Re: Marais Oxidation Pond Sewer
Treatment Rehabilitation OCD/DR
Number 04PARA2309 (Funding by
Louisiana Office of Community
Development/Disaster Recovery Unit
OCD G/I Project No. 04PARA2309)

ADDENDUM NO. 1

PROJECT: Marais Oxidation Pond Sewer Treatment Rehabilitation
OCD/DR Number 04PARA2309 (Funding by Louisiana Office
of Community Development/Disaster Recovery Unit OCD G/
Project No. 04PARA2309)

3.) REMOVE- EXISTING SHEET C.5 SEWER TREATMENT PLANT PLAN.

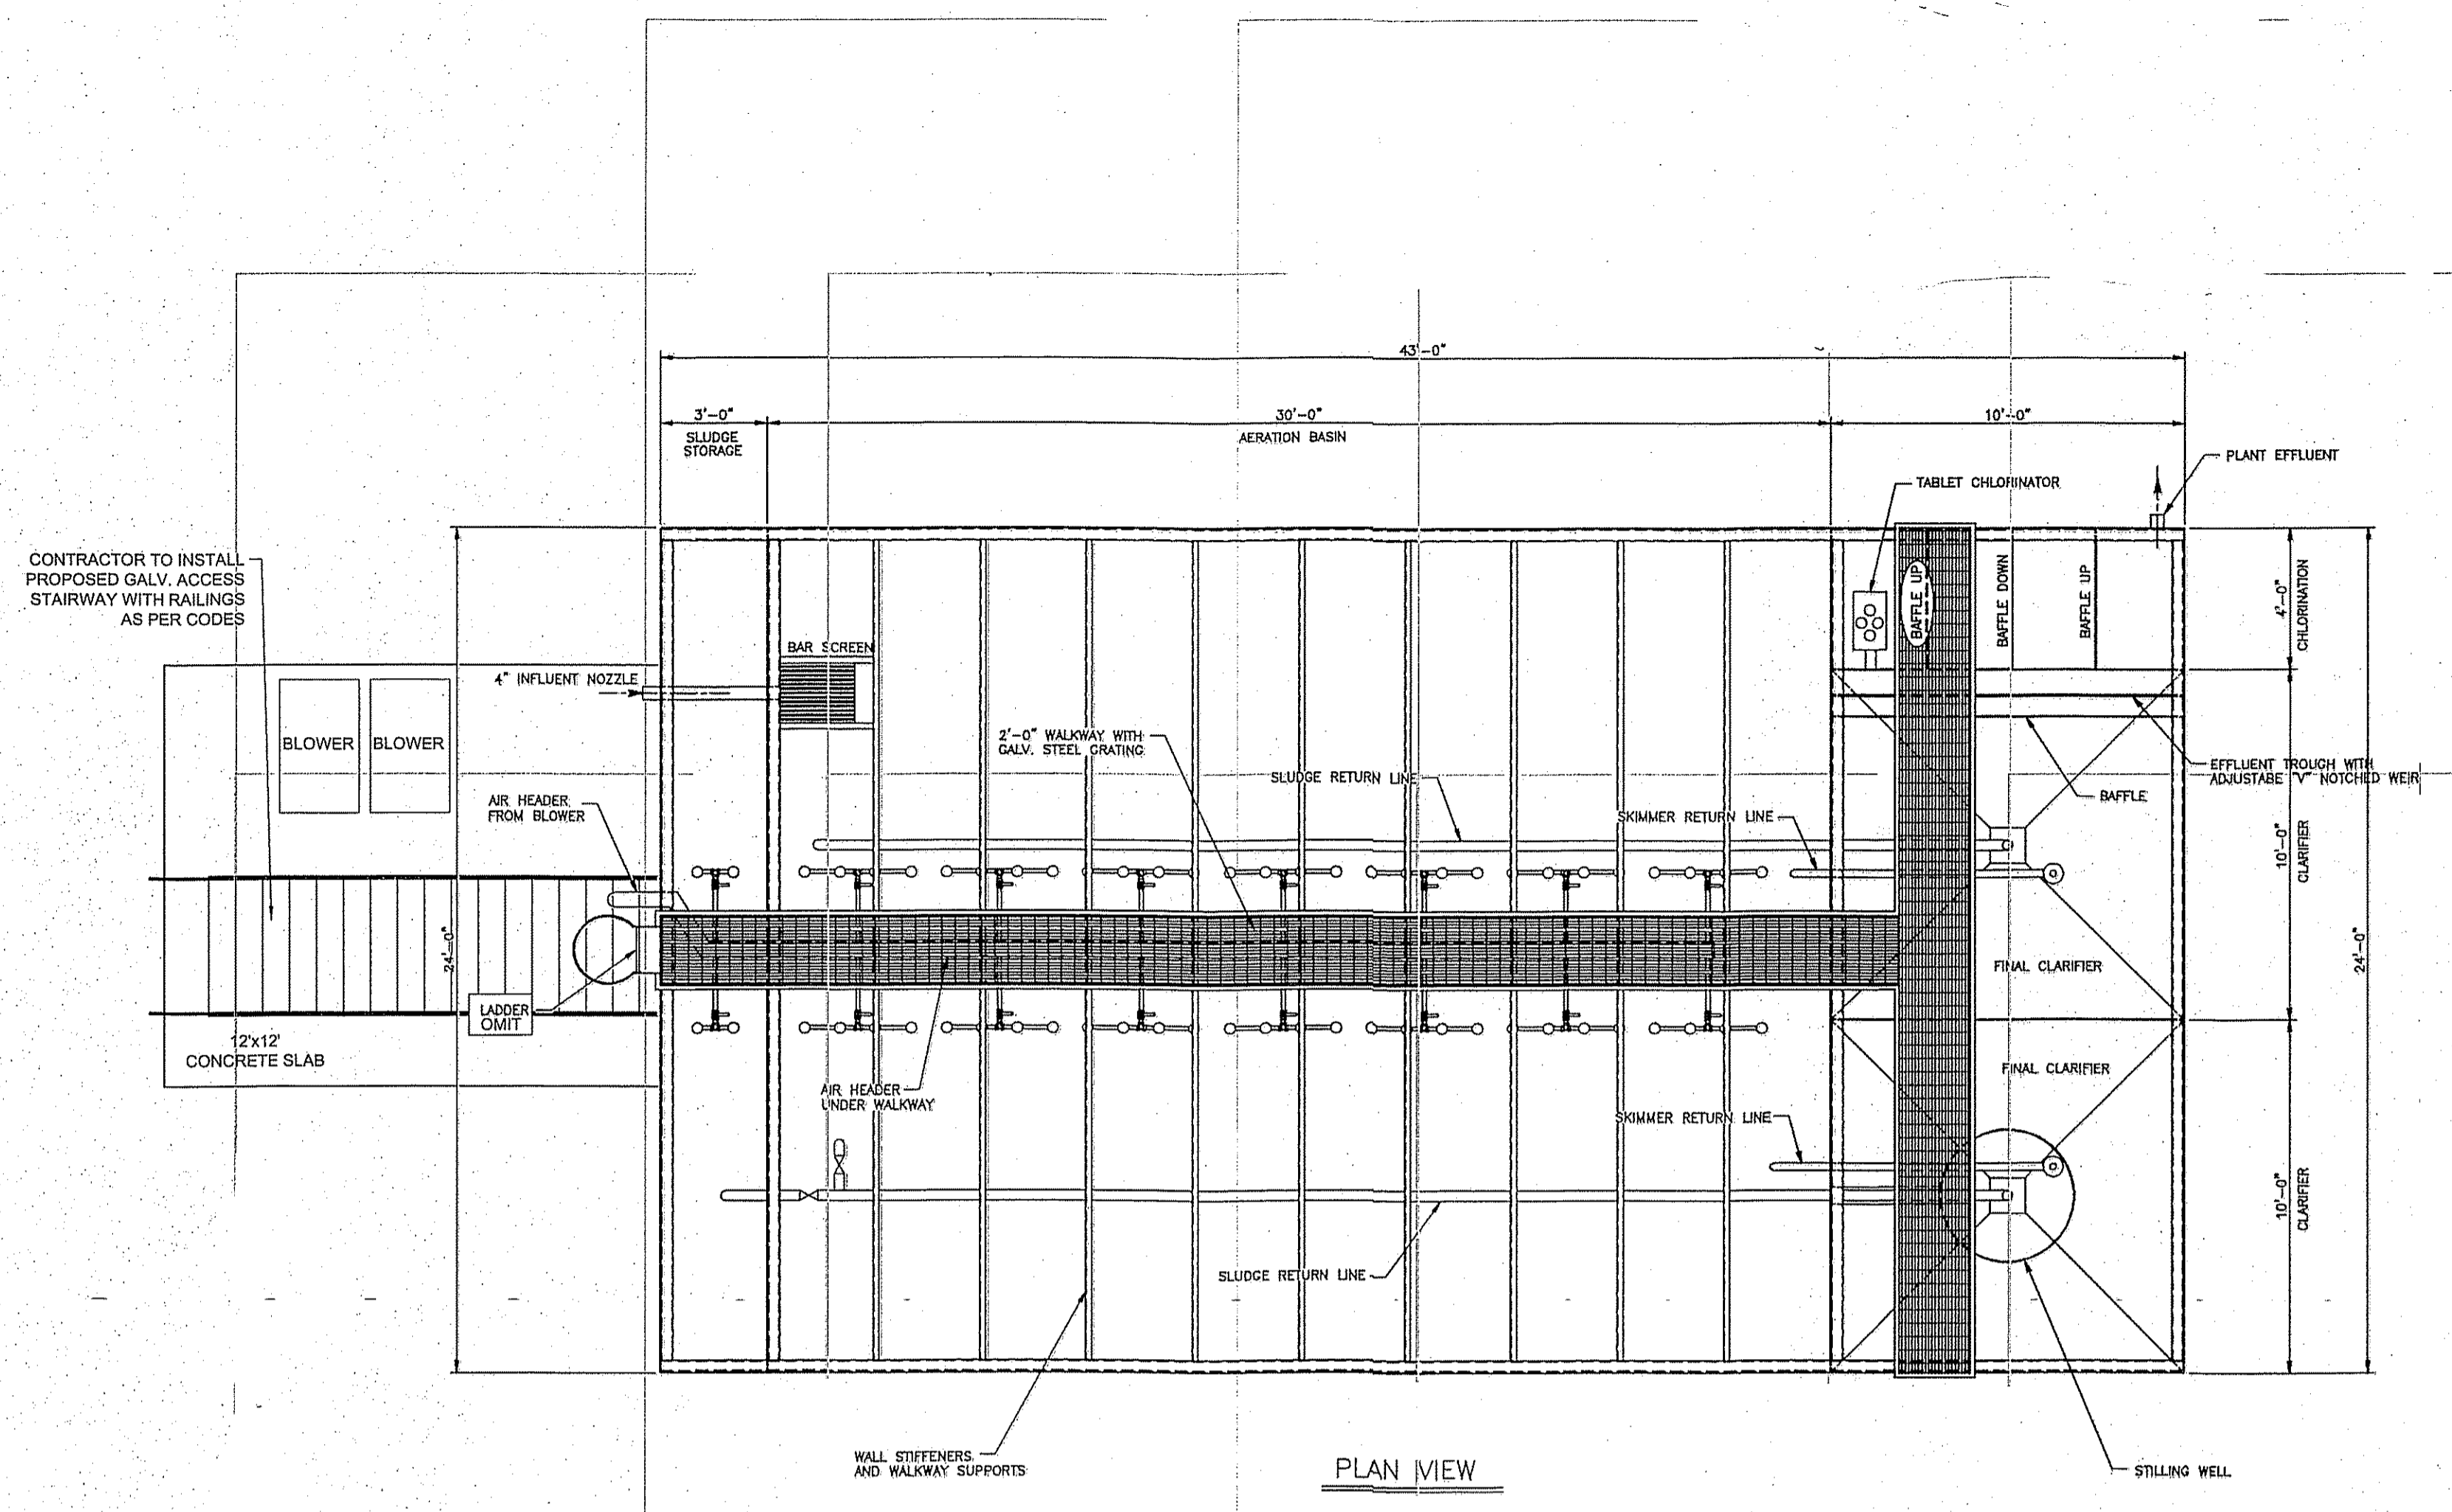
NOTE: AIR BLOWERS AND PLANT ELECTRICAL CONTROLS SHALL BE SINGLE PHASE.

REPLACE- ATTACHED REVISED SHEET C.5 SEWER TREATMENT PLANT PLAN.

| EXTENDED AERATION PLANT | |
|---|-------------|
| AERATION BLOWERS (15 hp, 1 PHASE, 60 CYCLE, 460V) | 320 CFM |
| CONTROL PANEL (1 PHASE, 60 CYCLE, 230 VOLT, 4 WIRE) | |
